**GOLDEN GATE PARK GOLF COURSE CLUBHOUSE
970 47TH AVENUE
SAN FRANCISCO, CA 94121**

**ESTIMATE OF PROBABLE CONSTRUCTION COST
BASED ON
100% DESIGN DEVELOPMENT**

M Lee Corporation
Project Query Sheet

Job Name: GGP Golf Course Clubhouse

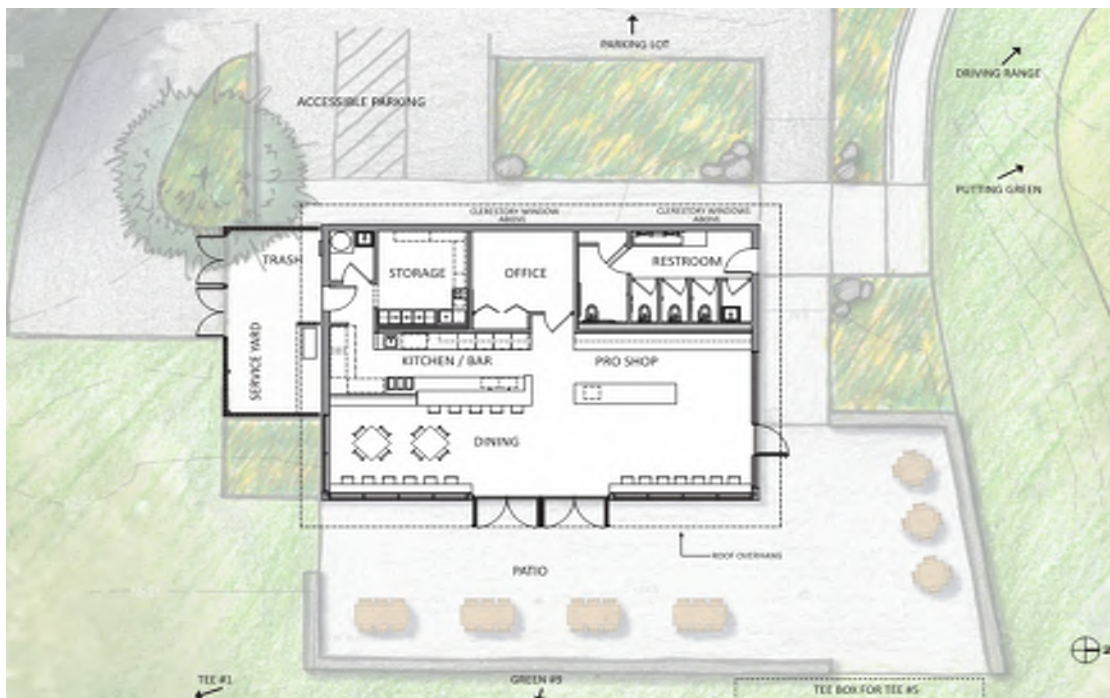
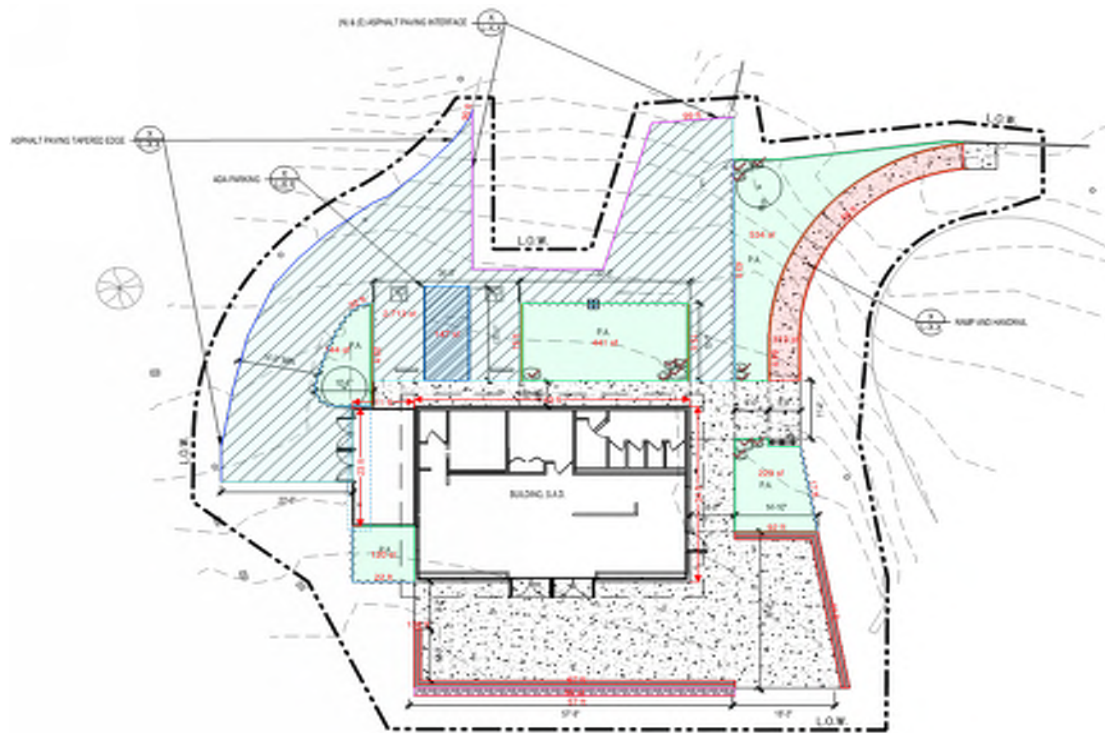
Item	Drwg/Spec	Queries	Answers
1	L1.0 and A1.20	On L.10 the (E) concrete bench and its footing is to be removed, while on A1.20 the (E) concrete bench is to remain. Please clarify this discrepancy 	L - 1.0 shall govern.
2	L1.0 and A1.20	There is a discrepancy between the area where (E) asphalt is removed on sheet L1.0 and A1.20. Please clarify which sheet governs.	L - 1.0 shall govern.
3	A2.10	What is the floor finish for retail/dining, pro shop, admin, restroom, and service yard?	All interior spaces other than kitchen/bar, prep/storage, and Utility room shall have polished concrete flooring (a polished 1" microtopping)
4	General	Could you provide us with structural drawings showing the concrete curb for the building?	Not on the structural drawings yet. Assume a 6" concrete curb.
5	General	We were provided with a cutsheet for multi-slide door but it is not shown in the plans. Please clarify where it is being used in the building.	This product will not be used. We will be using the 7620 series sliding windows here. Please see clarified elevation attached.

6	A3.40	Are security shutters to be placed around the windows on retail/dining and pro shop?	Roll down security shutters shall be provided at the interior of the windows (and doors), below the transom beam, at the pro shop and retail / dining space. The clerestory windows are omitted.
7	General	Are wall tiles to be placed on restroom walls?	Yes all restroom walls to be ceramic tile
8			
9			
10			
11			
12			
13			
14			
15			
16			
17			
18			
19			
20
